DORIS PLACE SUBDIVISION, RESUBDIVISION OF

LOT 1

APPLICATION NUMBER 5 DATE December 2, 2010

REQUEST Subdivision

DETAIL SITE PLAN

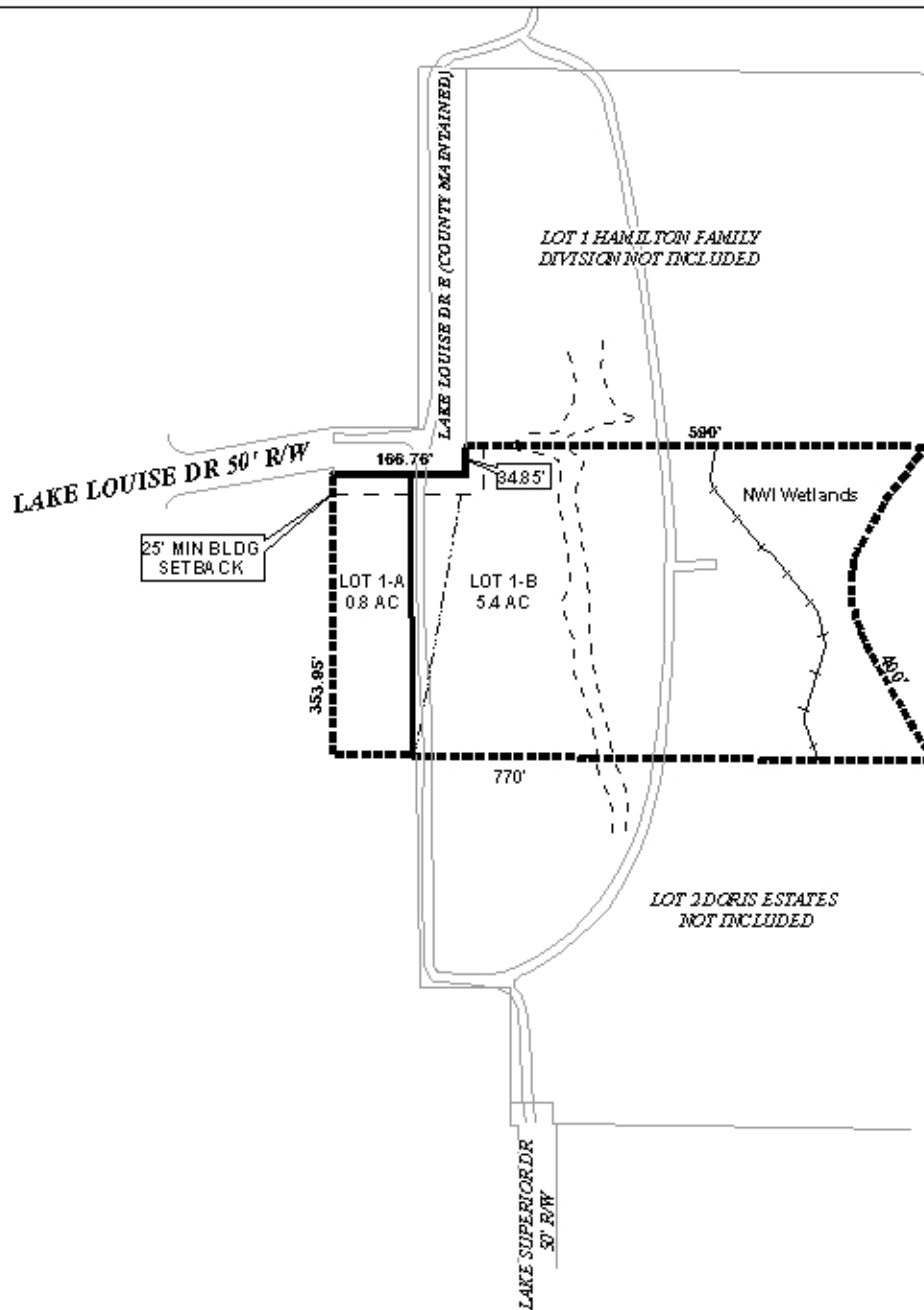
The site fronts Lake Louise Drive and Lake Louise Drive East with a compliant 60' right-of-way; therefore, no dedication would be required if this application is approved. It should be noted that the road is County-maintained but unpaved at this time. As on the plat, the 25' minimum building setback line should be illustrated on the final plat. Also, as on the plat, the final plat should label each lot with its size in both square feet and acres, or a note should be furnished on the final plat providing the same information.

As a means of access management, a note should be required on the final plat stating that each lot is limited to one curb cut to Lake Louise Drive, with the size, location and design to be approved by County Engineering and conform to AASHTO standards.

As proposed, Lot 1-A would exceed the maximum depth ratio (by approximately 4') as allowed by Section V.D.3. of the Subdivision Regulations. However, there are other properties in the vicinity which far greater exceed the ratio; therefore a waiver of Section V.D.3. would be justified.

Although not labeled, NWI wetlands exist on the Eastern portion of proposed Lot 1-B along Fowl River which indicate that the area may be environmentally sensitive; therefore, the

approval of all applicable federal, state and local environmental agencies would be required prior to the issuance of any permits or land disturbance activities. The plat should be revised to label the marshy area as NWI wetlands. The site is also located in floodplains, thus compliance with FEMA regulations will be required.

- 1) illustration of the 25' minimum building setback line along Lake Louise Drive and Lake Louise Drive East;
- 2) labeling of each lot with its size in both square feet and acres, or the furnishing of a table on the final plat providing the same information;

- 3) placement of a note on the final plat stating that each lot is limited to one curb cut to lake Louise Drive, with the size, location and design to be approved by County Engineering and conform to AASHTO standards;

- 5) revision of the plat to label the marshy area NWI wetlands and placement of a note on the final plat stating that development of the site must be undertaken in compliance with all local, state and Federal regulations regarding wetlands;
